INTERNATIONAL 420 CLASS ASSOCIATION

The 420 Class Association grants permission to add the following rule to the class rules:

C.10.3.1.(h)

Illustrative picture enclosed:

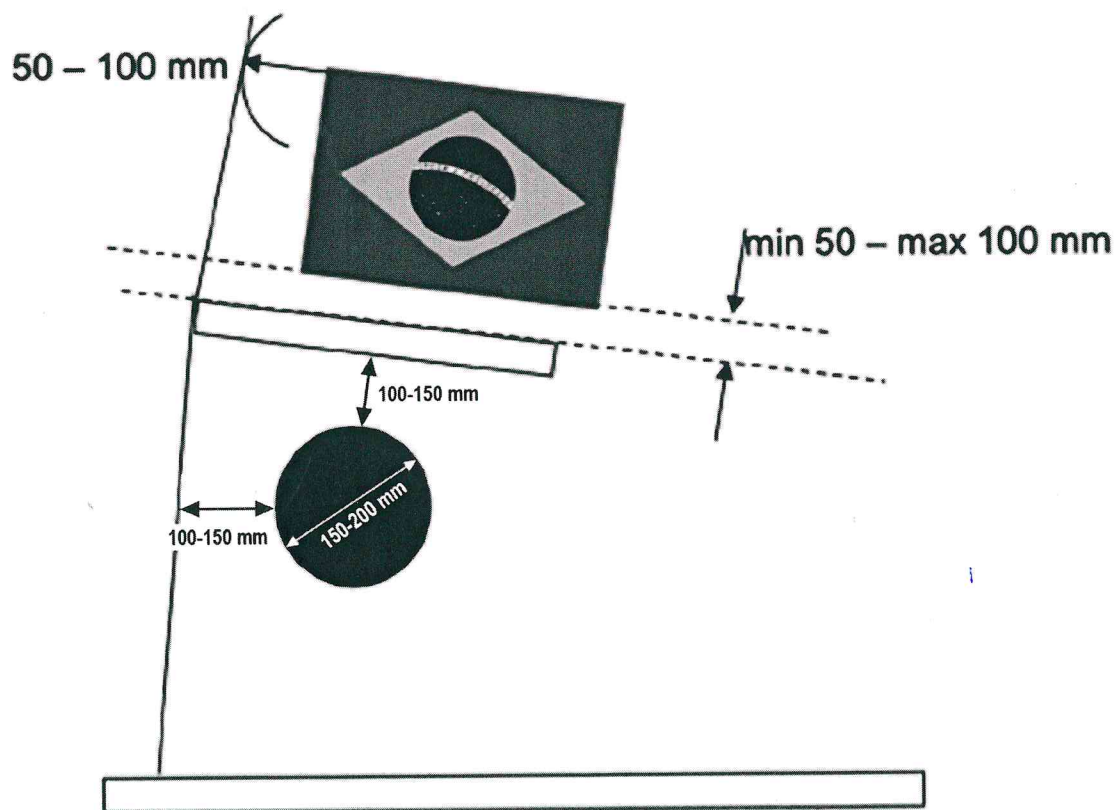
Mainsails used in U17 only events shall carry a blue circle (minimum diameter 150 mm, maximum 200 mm) below the lower batten pocket on both sides. The position should be between 100 and 150 mm from the lower batten pocket and between 100 and 150 mm from the leech.
